RE: SE 49-0718, VVK Realty, Inc.
1494 E. Rodney French Blvd

Comments and CLE responses from Nitsch letter dated December 11, 2015

PROJECT: PROPOSED FLOAT SYSTEM, MOORINGS,
EXISTING PIER REHABILITATION & SITE IMPROVEMENTS
1494 E. RODNEY FRENCH BLVD.
CLIENT: VVK REALTY, LLC; GREGORY KULPINSKI
99 FLAG SWAMP ROAD
NORTH DARTMOUTH, MA

SITE PLAN SHEET 1 OF 2

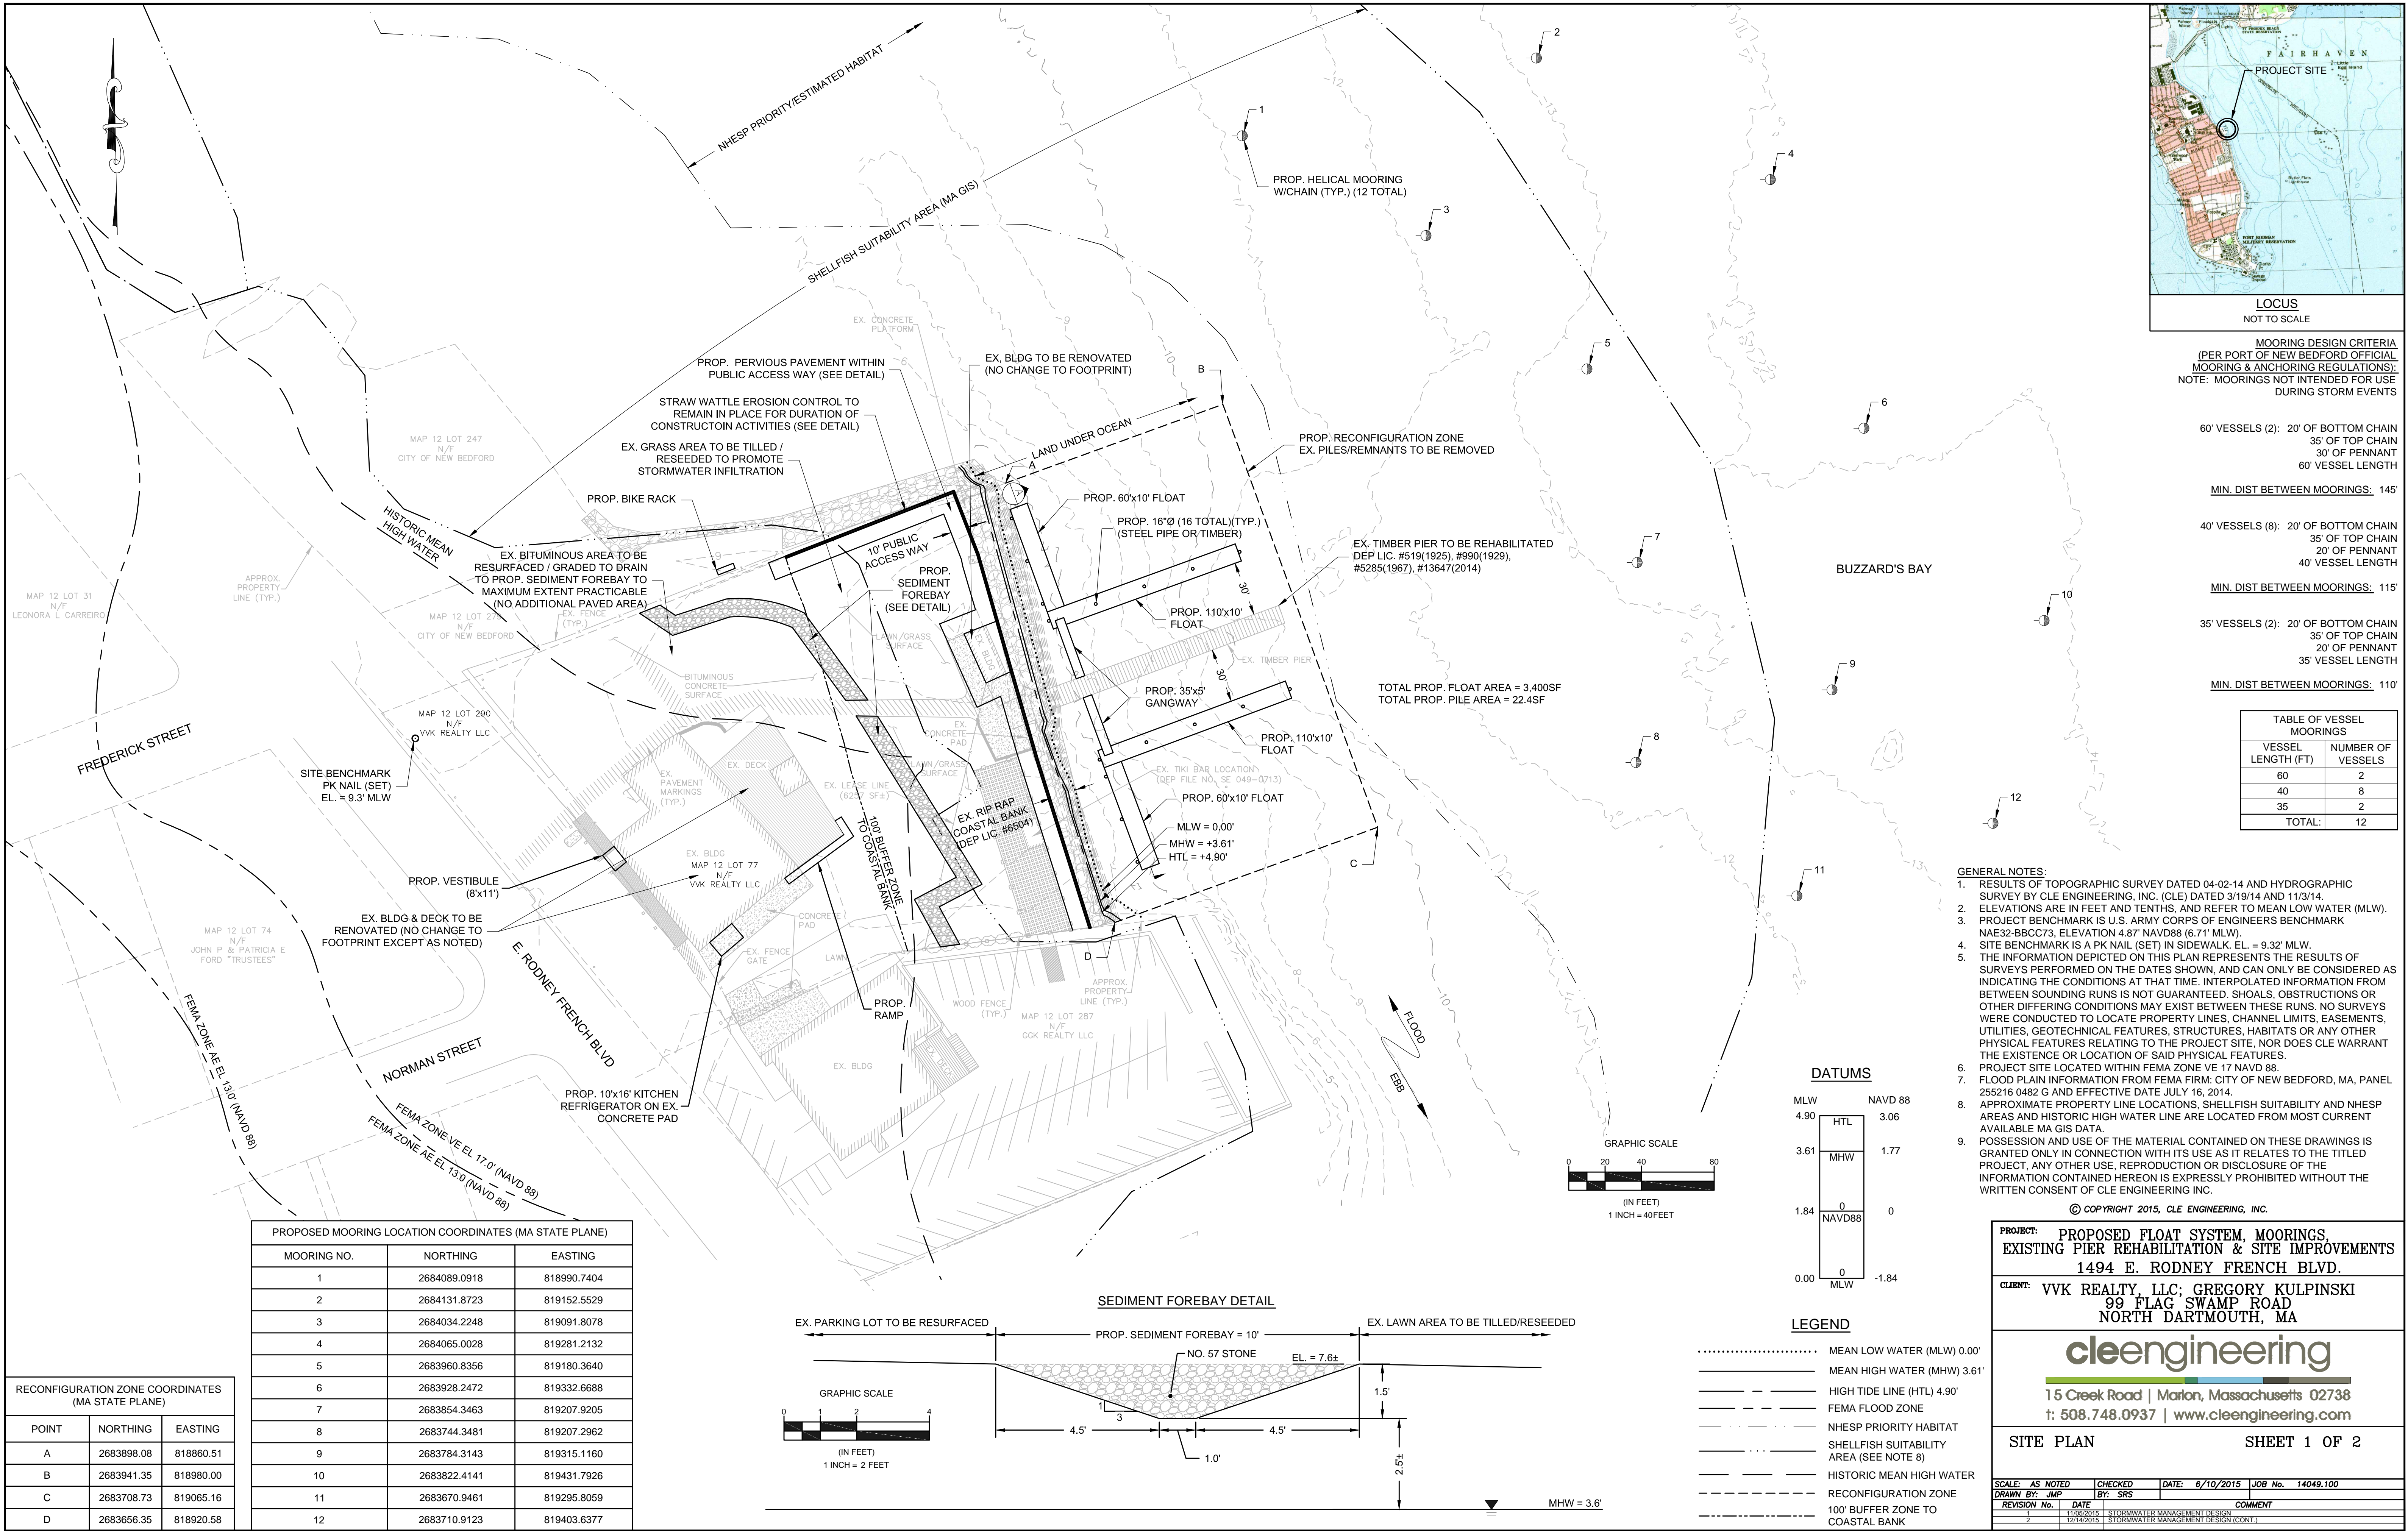
7. Please confirm if the crushed stone that was placed around the relocated tiki bar is to remain, or will be converted to grass.

The crushed stone west of the tiki bar is planned to be converted to grass.

PROPOSED PUBLIC ACCESS WAY PERVIOUS PAVEMENT - DETAIL

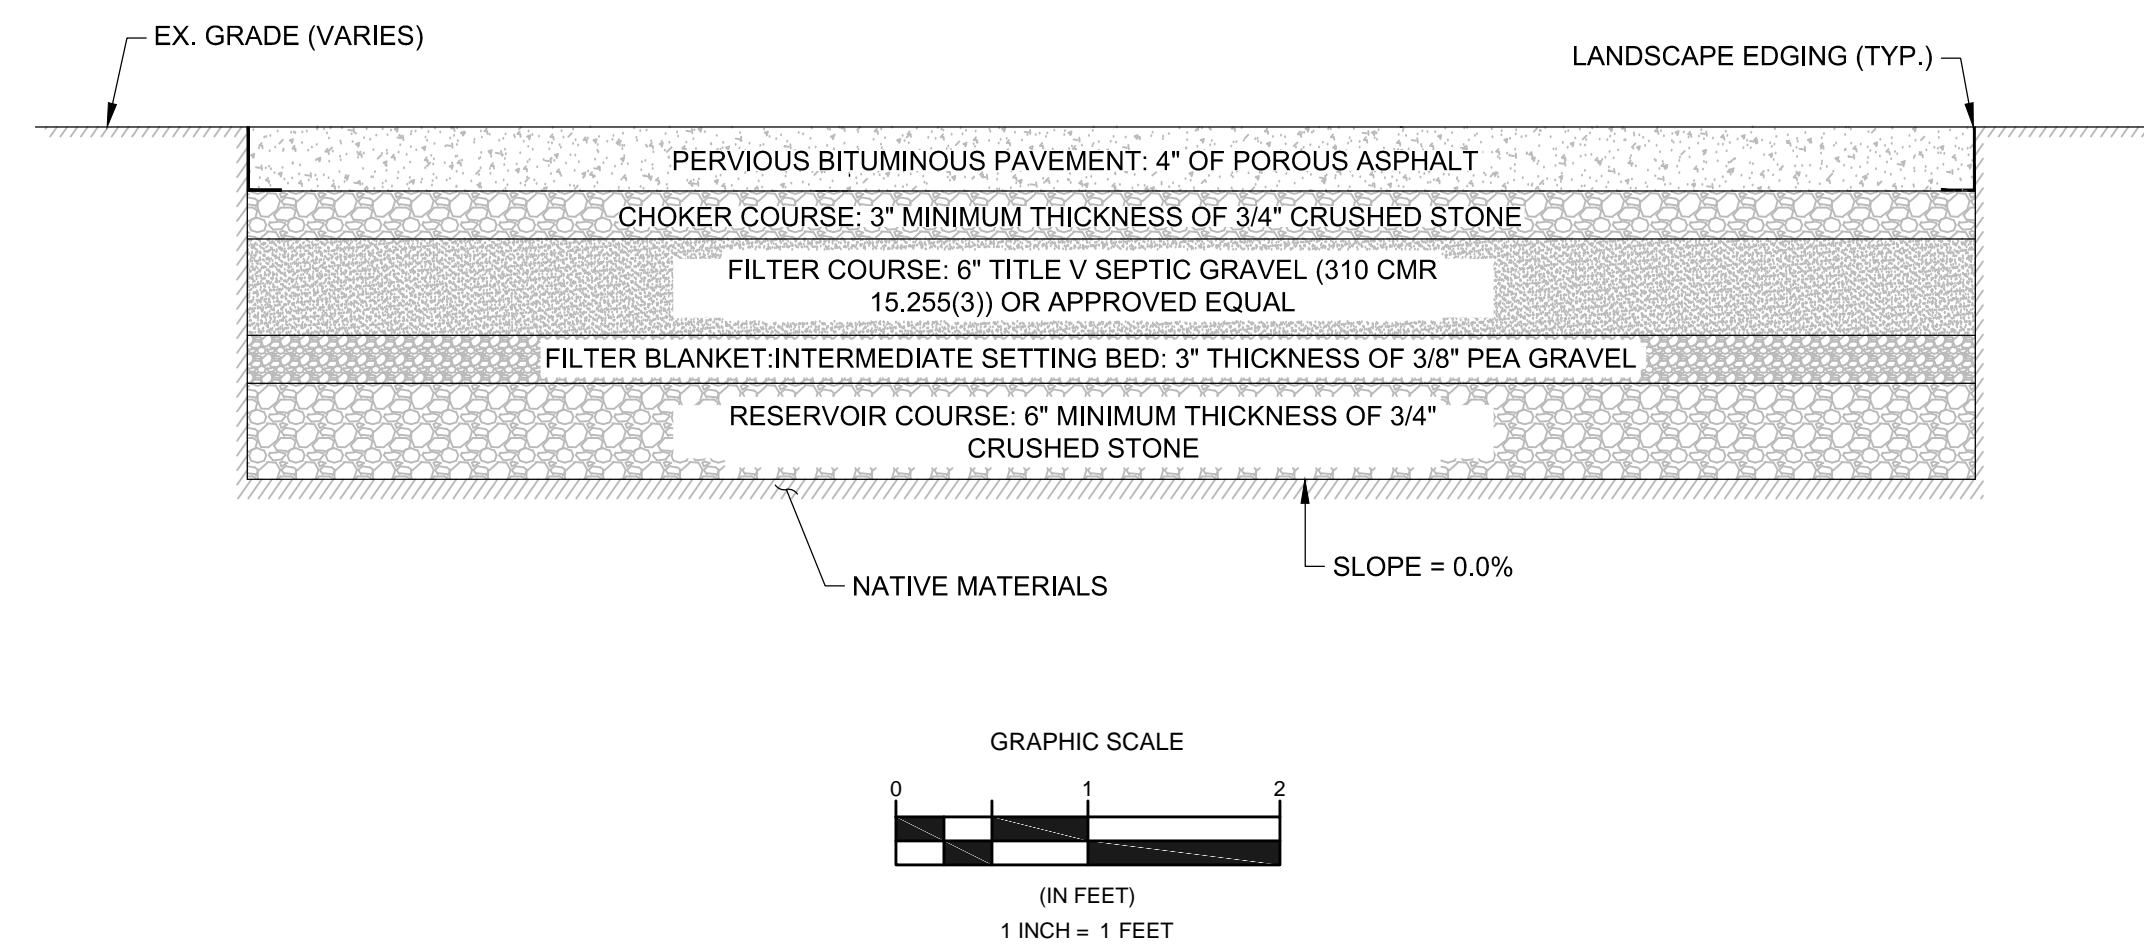
8. Design details should be provided for the permeable paver walkway.

A detail for the pervious pavement has been added to the plan set.

STRAW WATTLE DETAIL

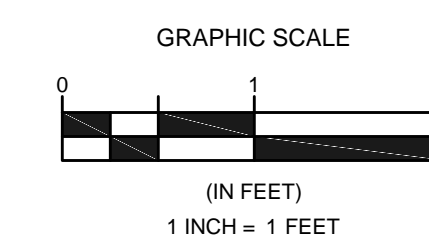
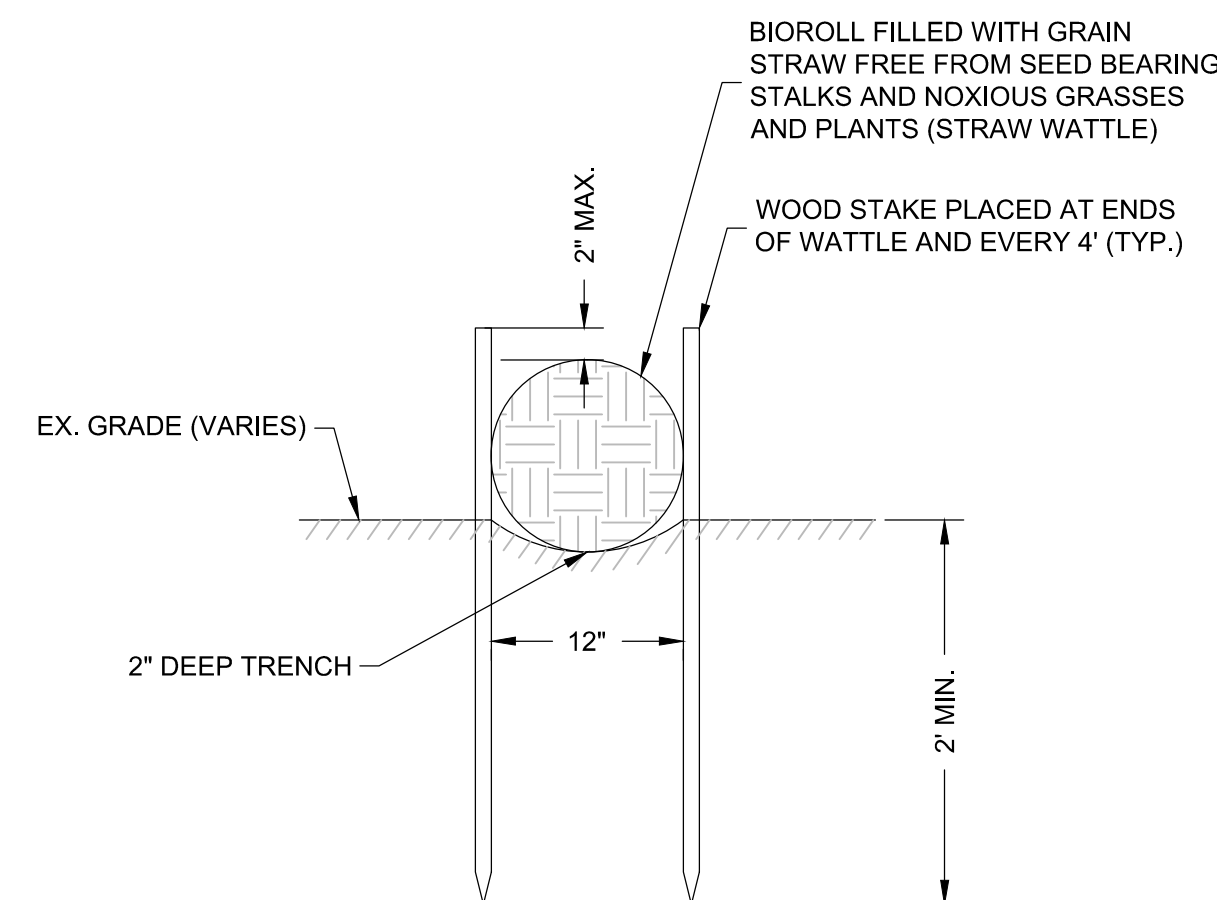
5. A construction period erosion and sedimentation control plan was not provided by the Applicant and is required for redevelopment projects. The requirements for the plan are outlined under Standard 8 and, specific to redevelopments, in Volume 2, Chapter 3 of the MassDEP Stormwater Handbook. The site plan indicates that wattles are proposed along the project boundary, but a detail is not provided. Details of all erosion controls should also be provided in the plan set.

Construction period erosion and sedimentation control was added to the plan set and includes details for the straw wattles.
